Re: West Sewage Treatment Plant (STP) Improvements
Change Order No. 4
City of Crest Hill, Illinois (City)

CHANGE ORDER NO. 4

PROJECT: West Sewage Treatment Plant (STP) Improvements
OWNER: City of Crest Hill, Illinois
CONTRACT: 1-2022
CONTRACTOR: Vissering Construction Company

SHEET
130
C45-E1.01

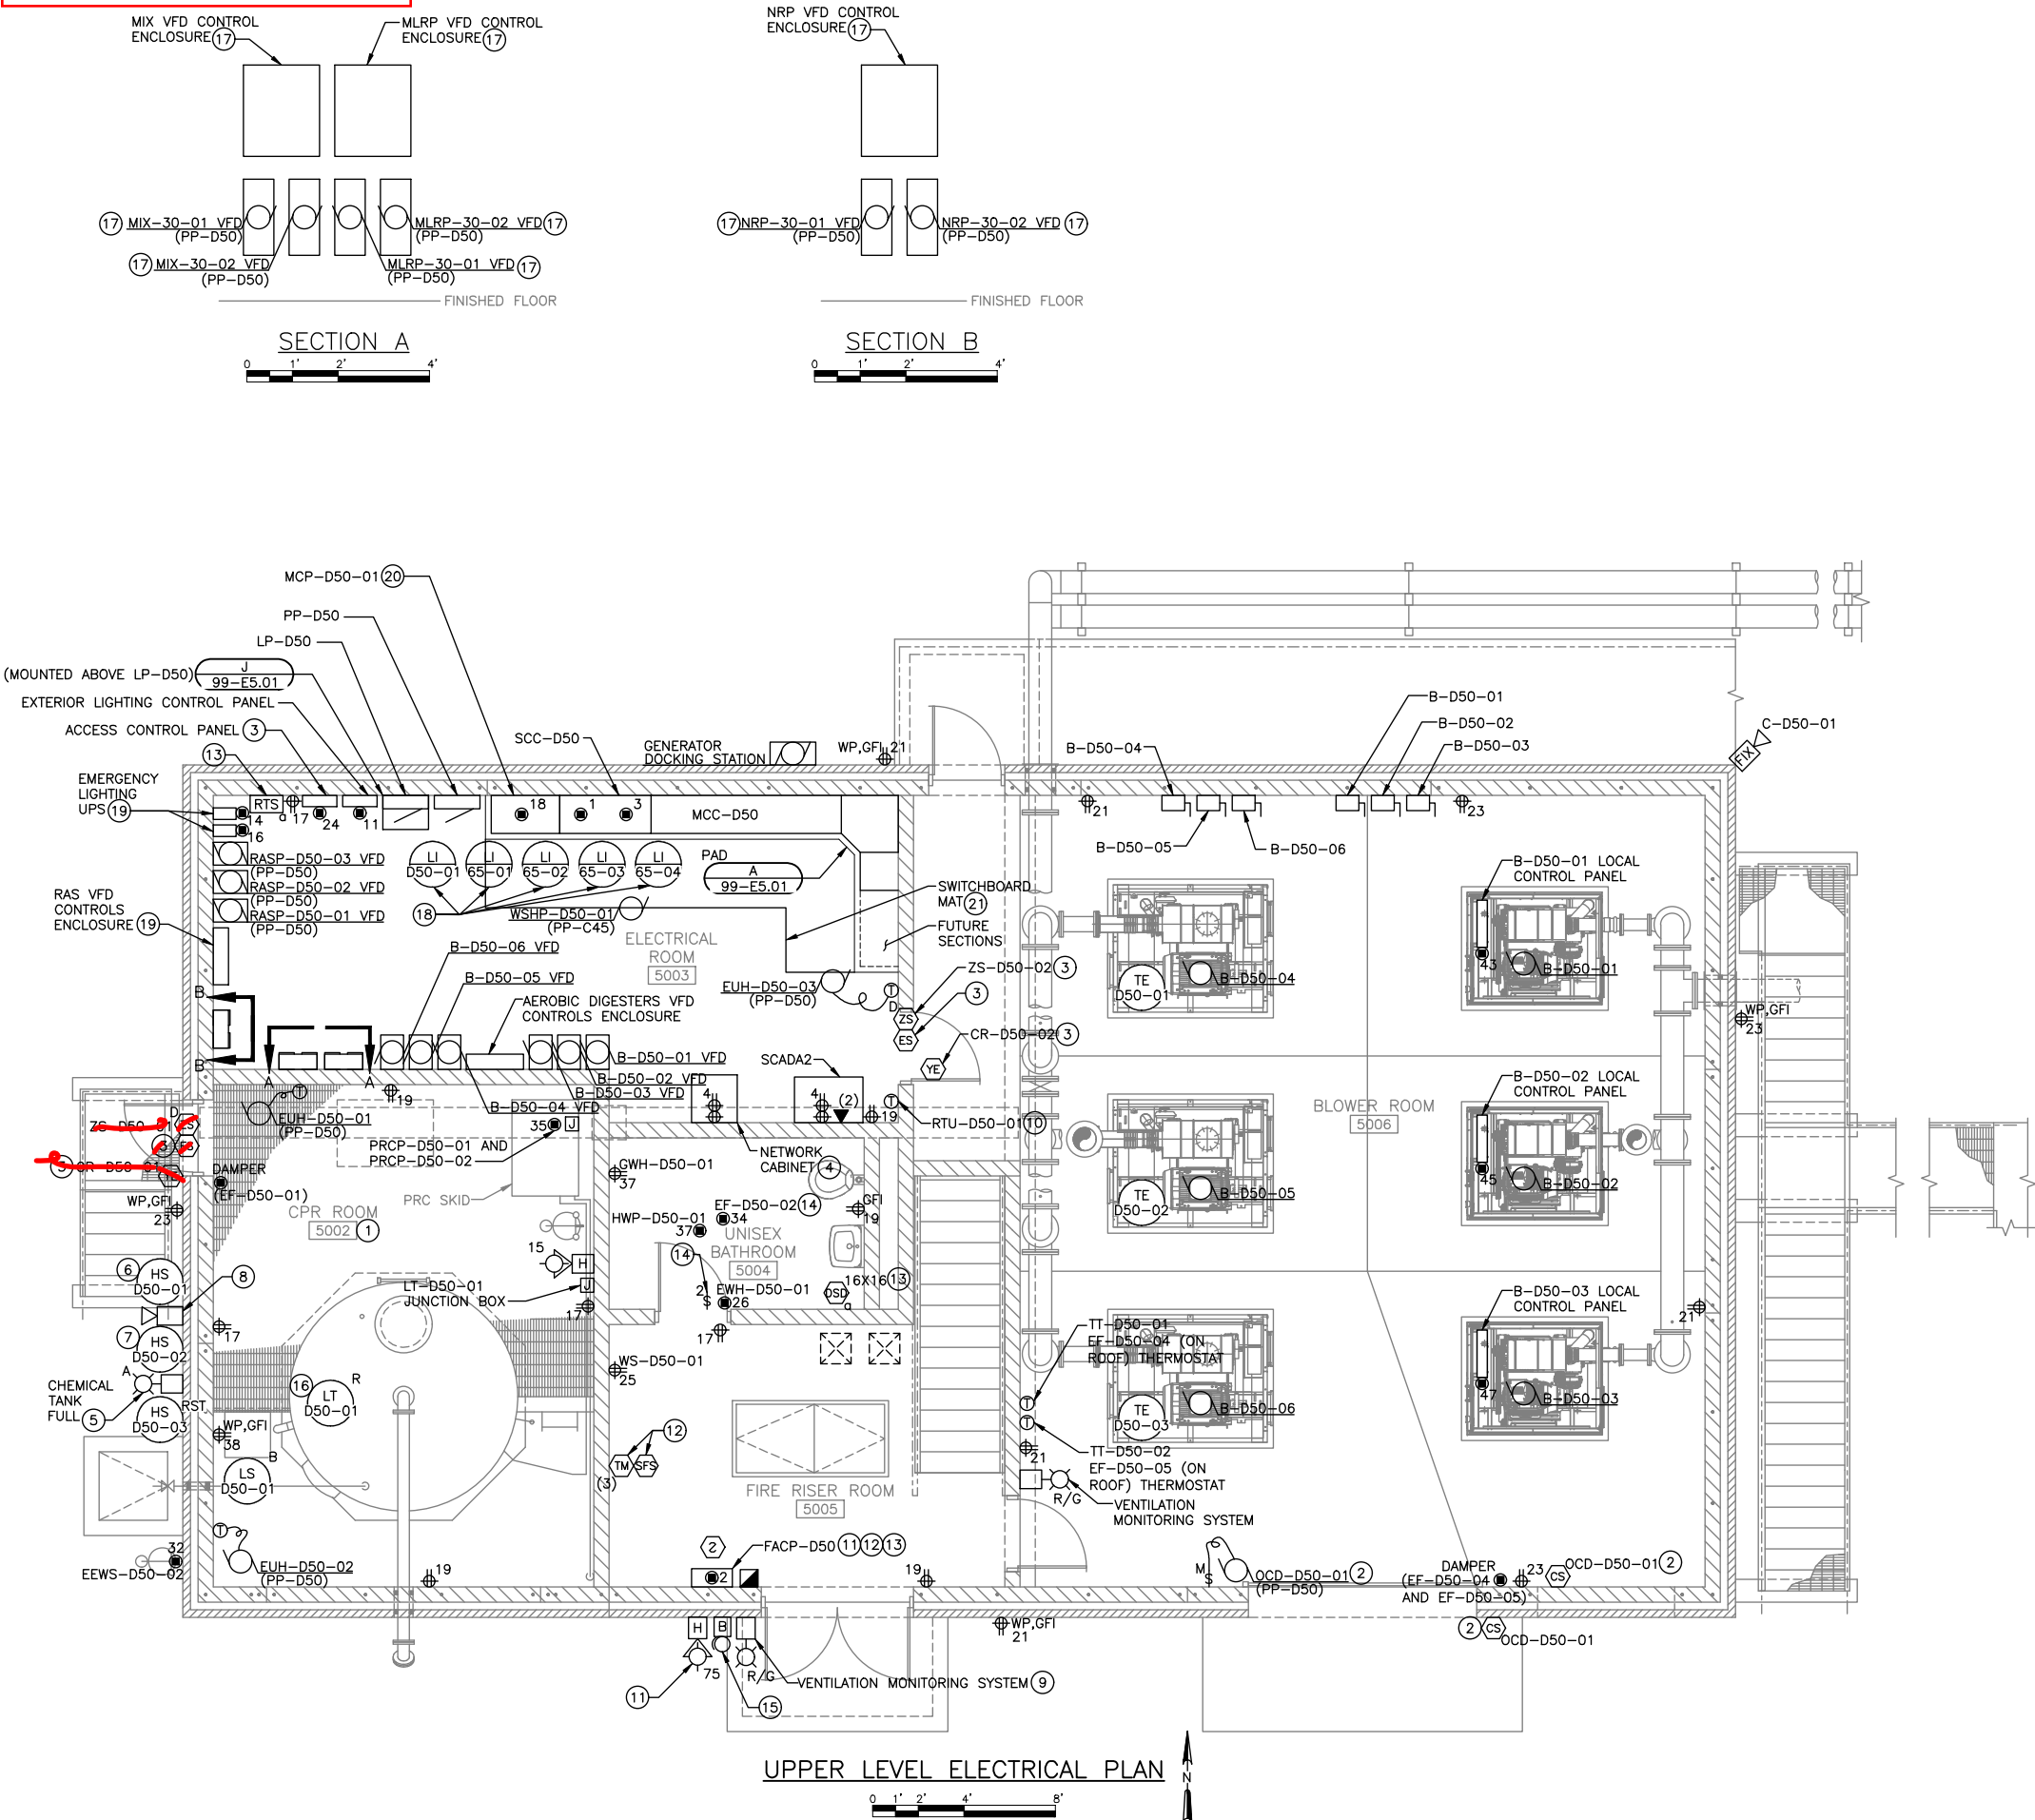
011-03 Drawing C45-E1.01 (Sheet 130)

Refer to the attached updated drawing showing revisions to the access control system. Changes include deletion of the system for the Filter Room 4501 at Door 4501A.

SHEET
197
E70-E1.01

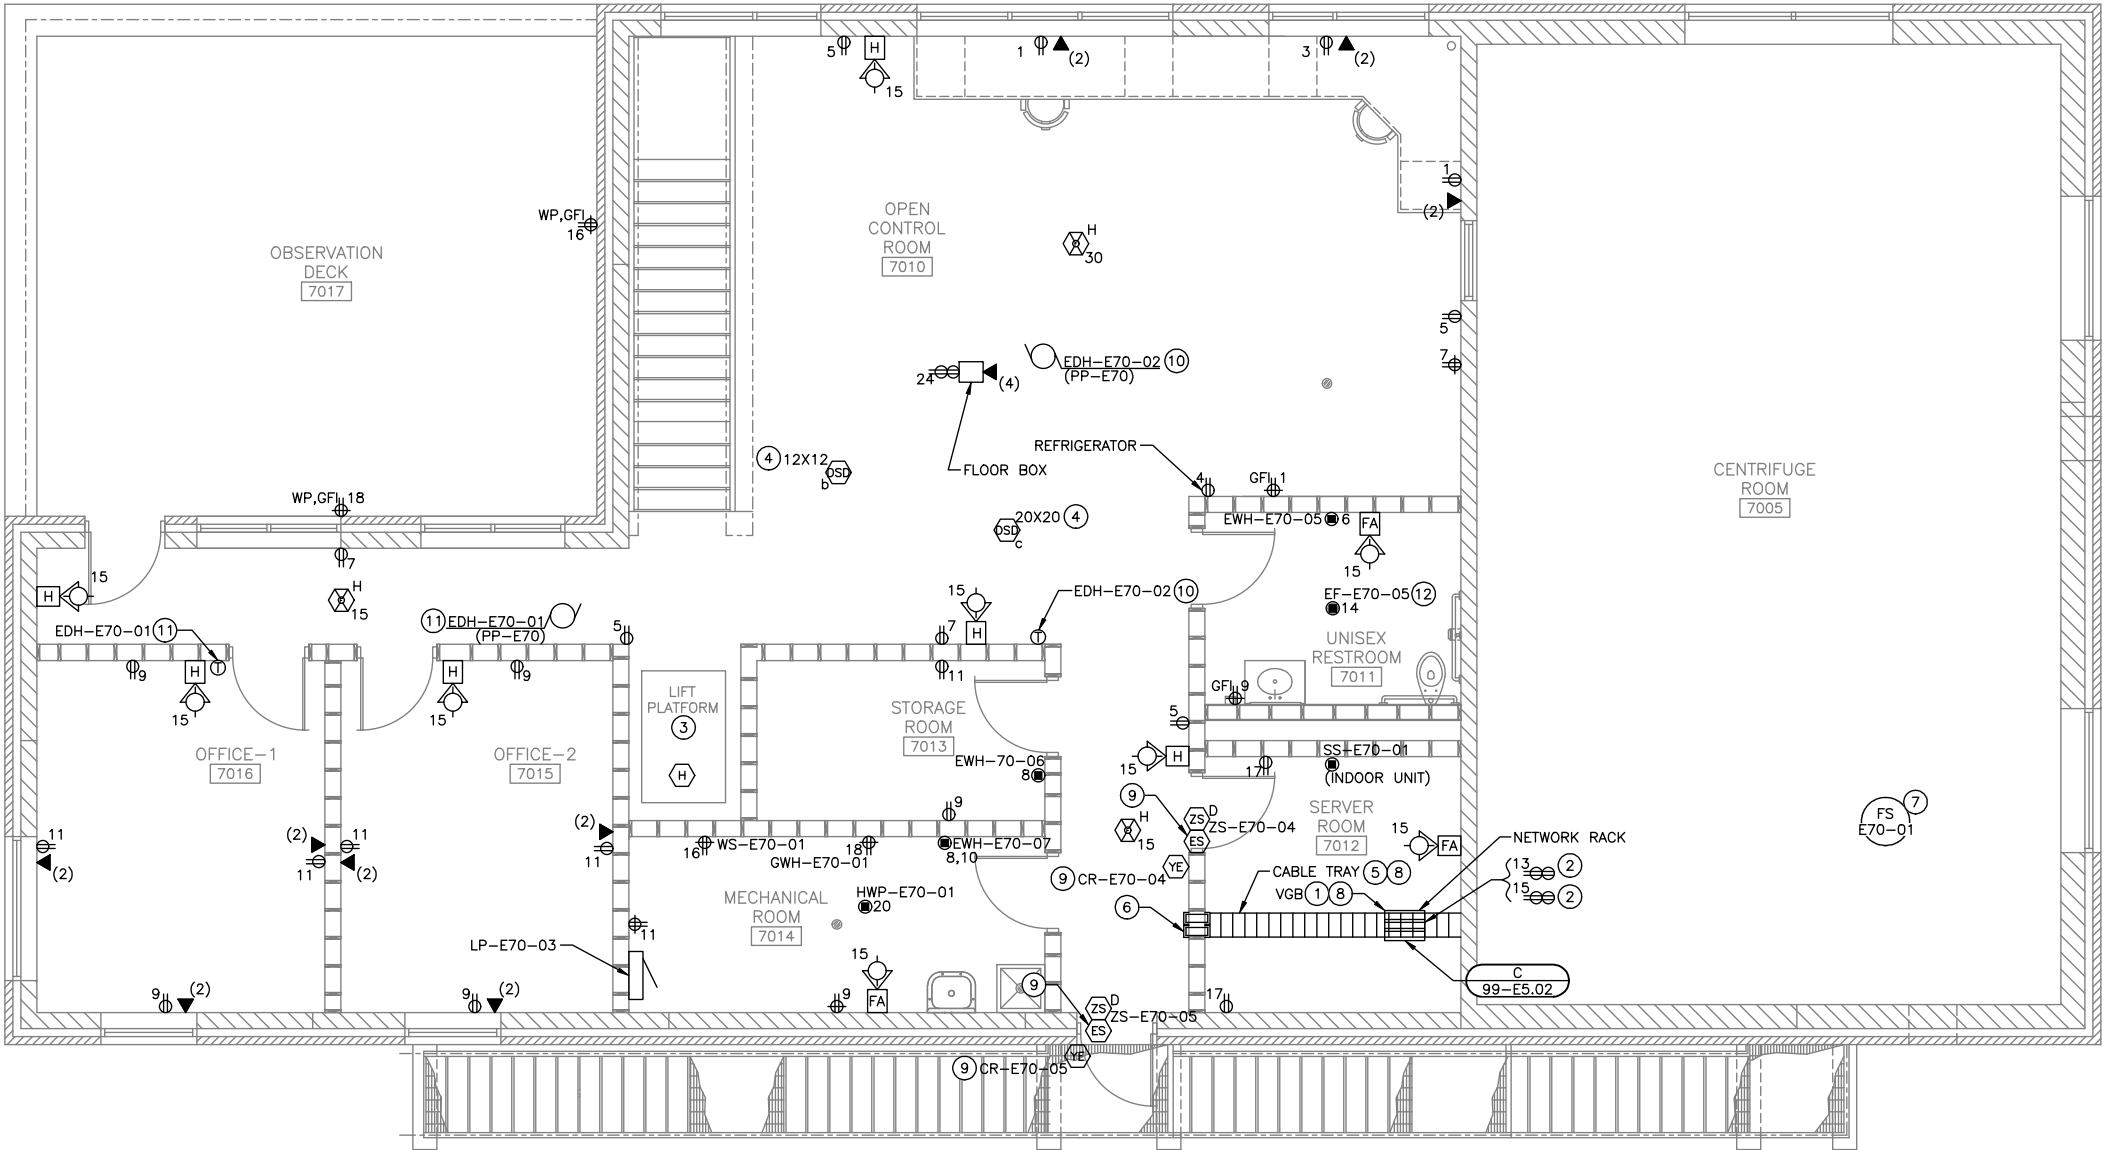
011-05 Drawing E70-E1.01 (Sheet 197)

Refer to the attached updated drawing showing revisions to the access control system. Changes include addition of the system for the Centrifuge Room 7005 at Door 7005A.

SHEET
63
15-ASM3.01

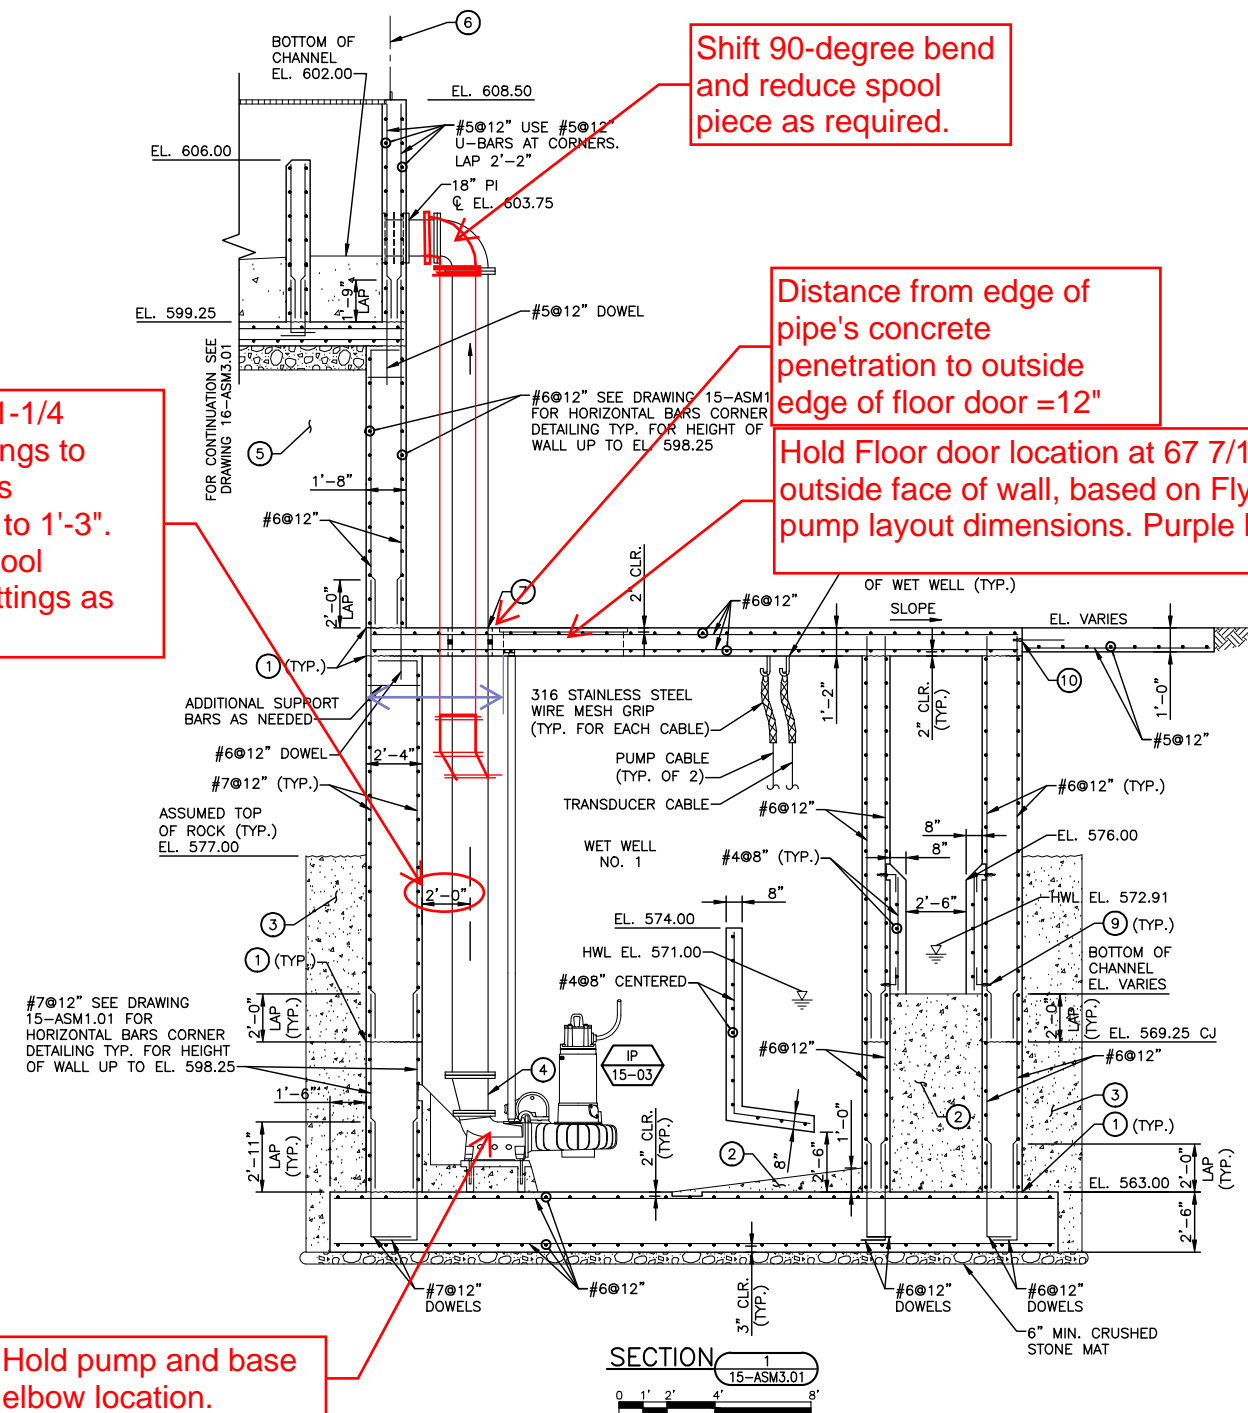
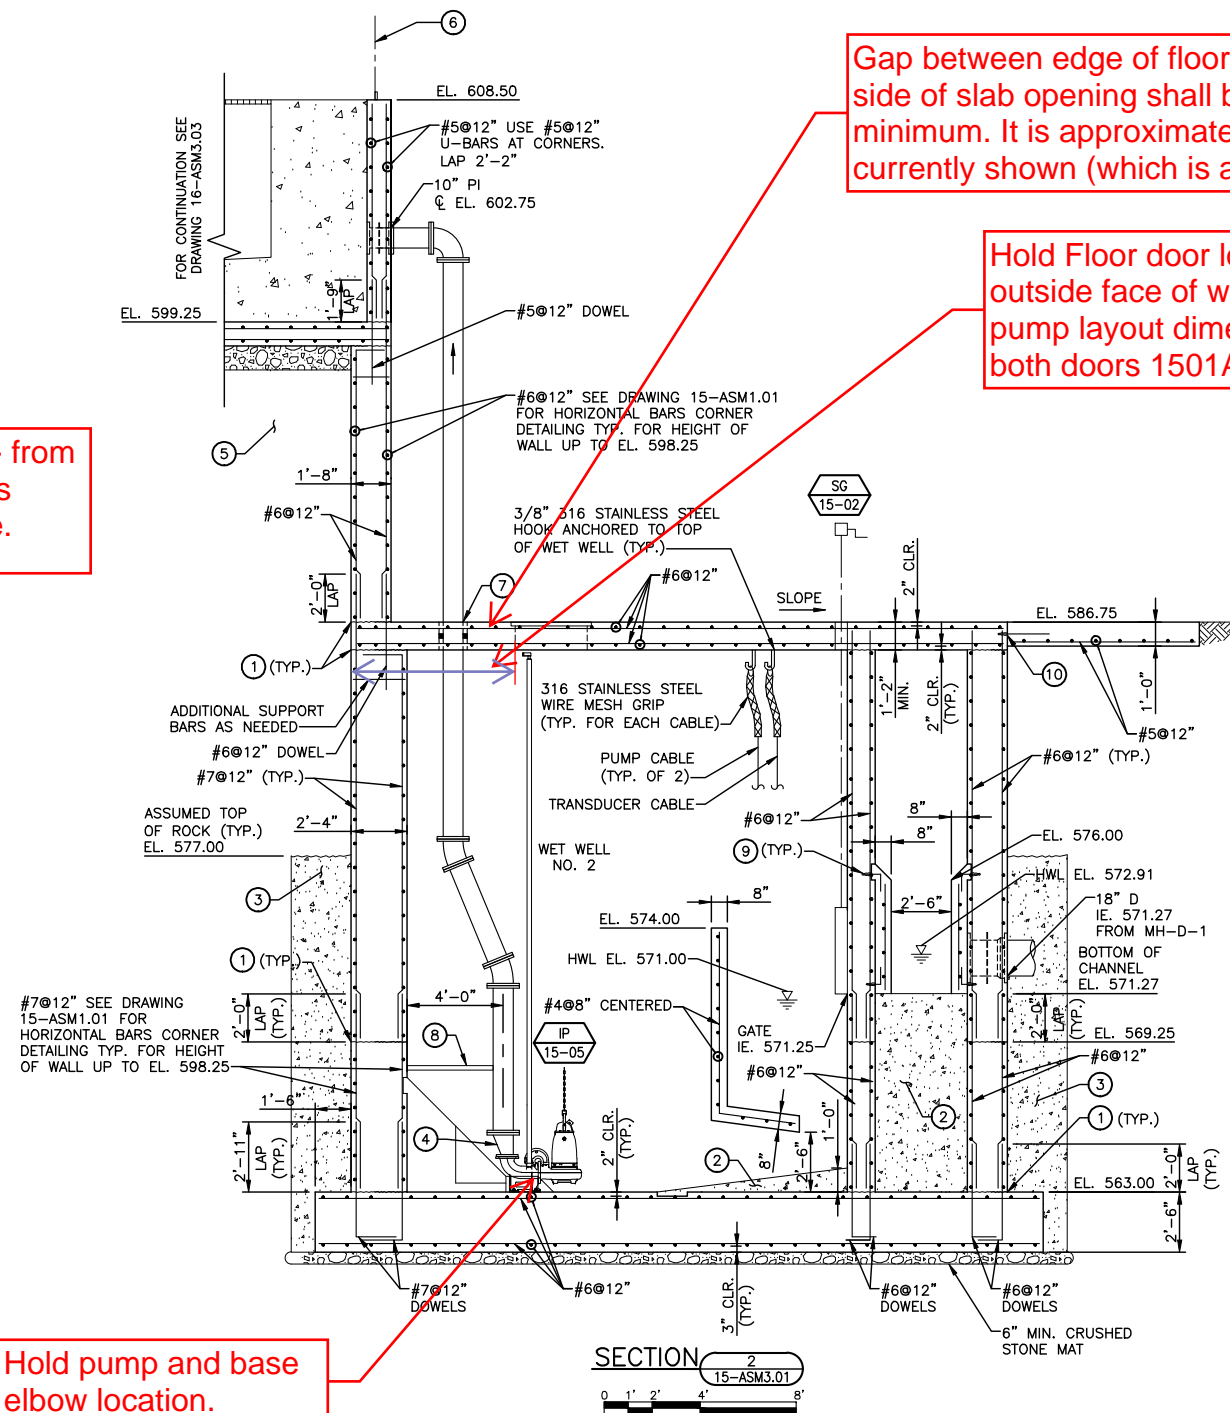
Hold Floor door location at 67 7/16"- from outside face of wall, based on Flygt's pump layout dimensions. Purple line.

Gap between edge of floor door and right side of slab opening shall be 12" minimum. It is approximately 24" as currently shown (which is acceptable).

Hold Floor door location at 82"- from outside face of wall, based on Flygt's pump layout dimensions. Purple line. Typ both doors 1501A and D.

Hold pump and base elbow location.

Hold pump and base elbow location.
